UPDATED: URGENT Field Safety Notice

Trilogy Evo, Trilogy Evo O2, Trilogy EV300
Flow Sensor Nebulized Aerosol Deposition

21-NOV-2024

Reference: Flow Sensor Nebulized Aerosol Deposition
Trilogy Evo, Trilogy Evo O2, and Trilogy EV300
2024-CC-SRC-013

Figure 1: Acceptable In-Line Nebulizer Placement

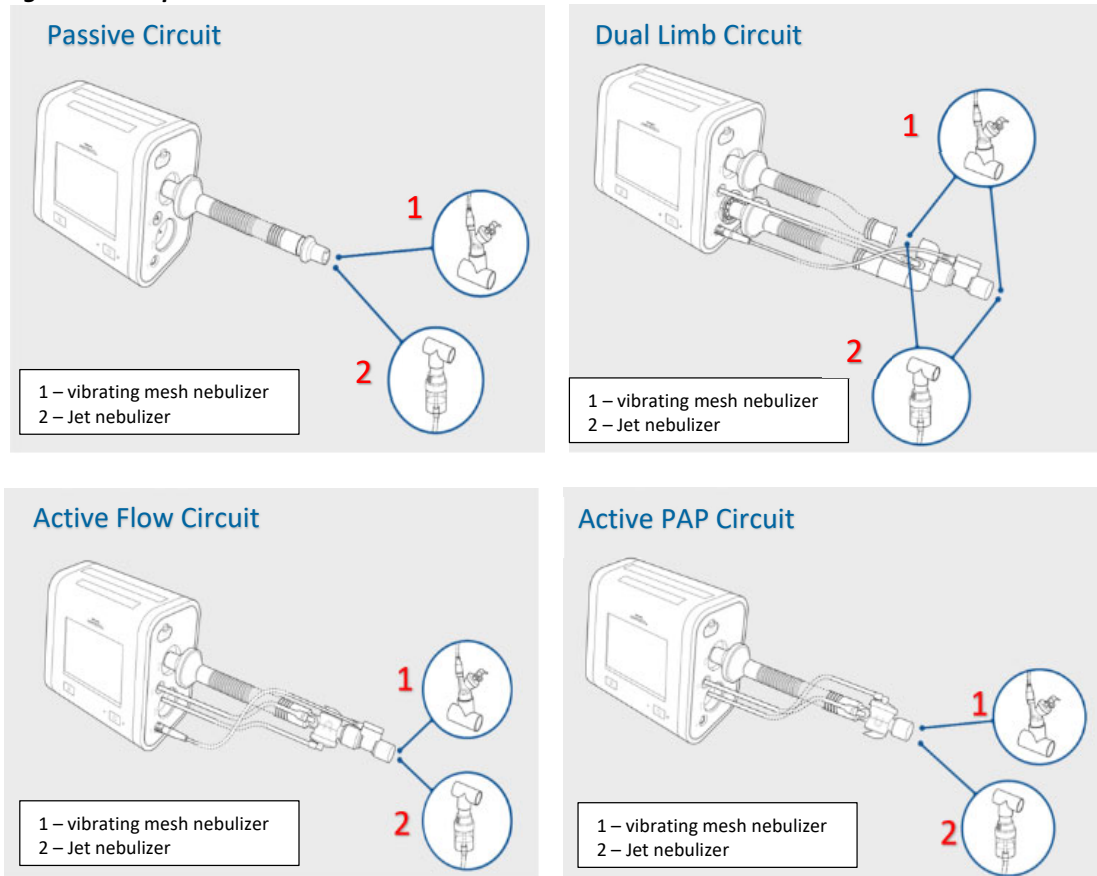
- **If using in-line nebulizer treatments:**
 - The circuit must be configured as pictured in the images in **Figure 1** below.
 - For prescriptions needing tidal volumes greater than 700 mL with a passive circuit, transition patient to alternate circuit (Active PAP, Active Flow, or Dual Limb).

- When tidal volumes greater than 700 mL are used with a passive circuit, nebulized aerosol deposition can occur even if the nebulizer is placed as pictured.

Appropriate Circuit Configurations for Use With In-Line Nebulizers

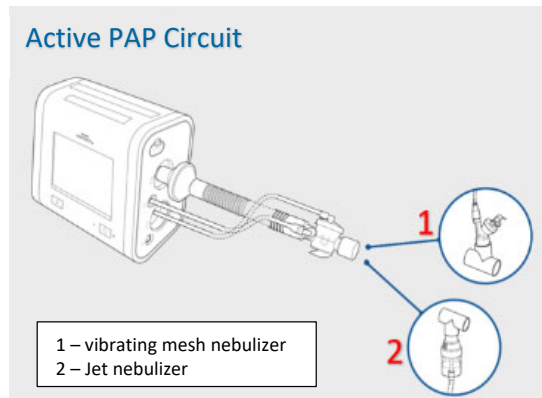
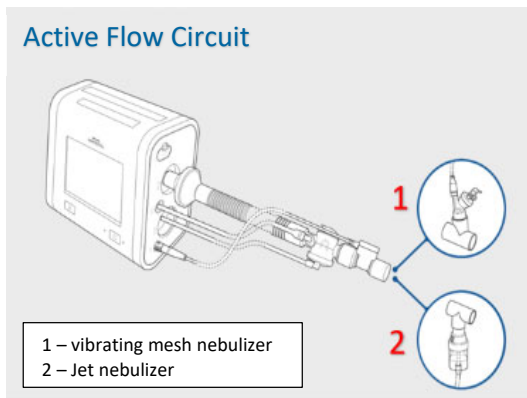
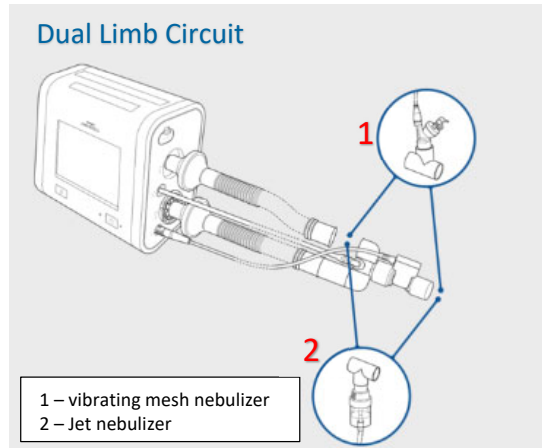
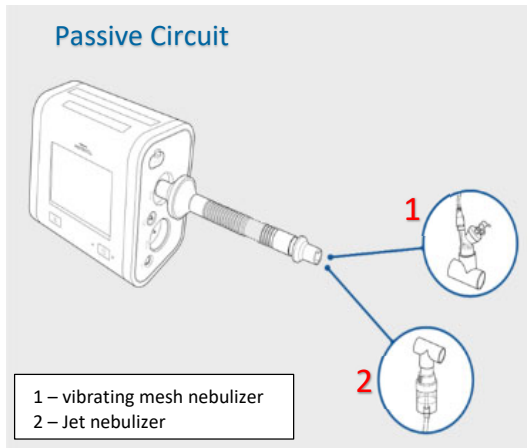
If using in-line nebulizer treatments, ensure the circuit is configured as shown in the images below.

Note: For prescriptions needing tidal volumes greater than 700 mL with a passive circuit, transition patient to alternate circuit (Active PAP, Active Flow, or Dual Limb).

- When tidal volumes greater than 700 mL are used with a passive circuit, nebulized aerosol deposition can occur even if the nebulizer is placed as pictured.
